September 15, 2016

**Re:** Arborist Review Tree Permit #2016-ARP-0040, Review and Recommendations  
**Site:** Nor Wes property, 190XX 195th St. (parcel #4022903193), Lake Forest Park, WA 98155.

**EXISTING TREES AND TREE REMOVAL SITE PLAN**

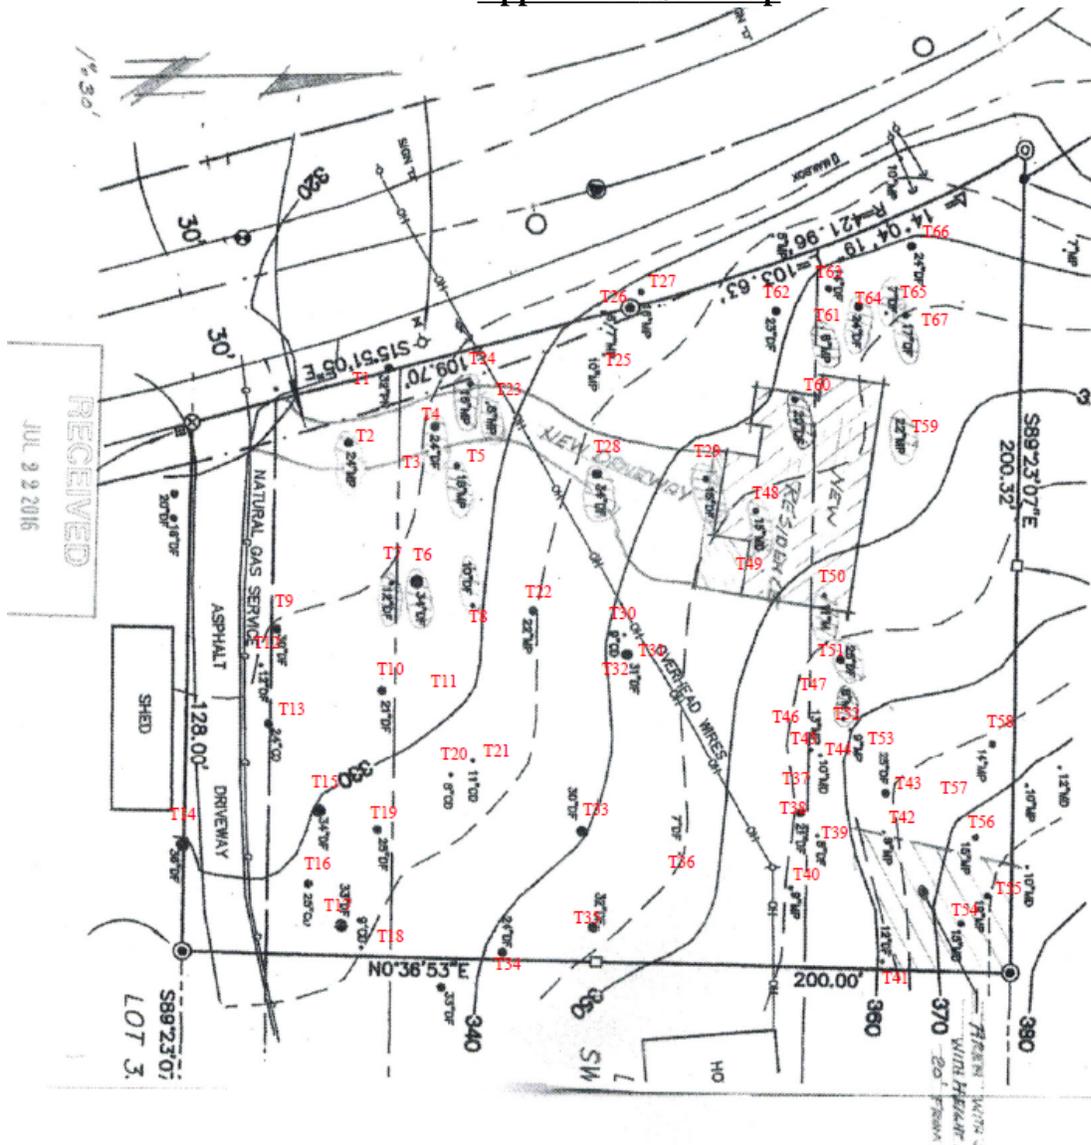
There are sixty seven (67) significant trees on the lot that were inventoried and assessed. A total of twenty (20) trees are proposed or recommended for removal and a total of forty seven (47) trees are proposed to retain, see Attachment : *Table of Trees*, for complete inventory and assessment and Appendix B: *Site Plan*, for tree locations.

The 20 trees that are located within or near the proposed building site and driveway that are unsuitable to retain or that can be adequately protected that are proposed to be removed to allow the project to be completed safely and as planned. Removal of all 20 trees will reduce the total tree canopy coverage by approximately 11,221sq. ft. (35%)

There are 47 trees that are proposed to retain. Most of the trees to be retained are located outside of the proposed construction boundary and should not be impacted by construction activities. For those trees proposed to be retained that are within the construction boundary they are generally in good overall health and condition and have the potential to tolerate construction activities, provided the recommended tree protection measures described in Appendix C: *Tree Protection Specifications* are followed. Retention of all 47 trees will leave approximately 19,101 sq. ft. (60%) of canopy coverage on the lot.

Any of the trees that are currently proposed for removal that are determined, by the final site plans, or changes in the site plans, and the onsite preconstruction meeting, as not being necessary to remove and that are suitable to tolerate proposed construction activities, should be retained and tree protection measures followed.
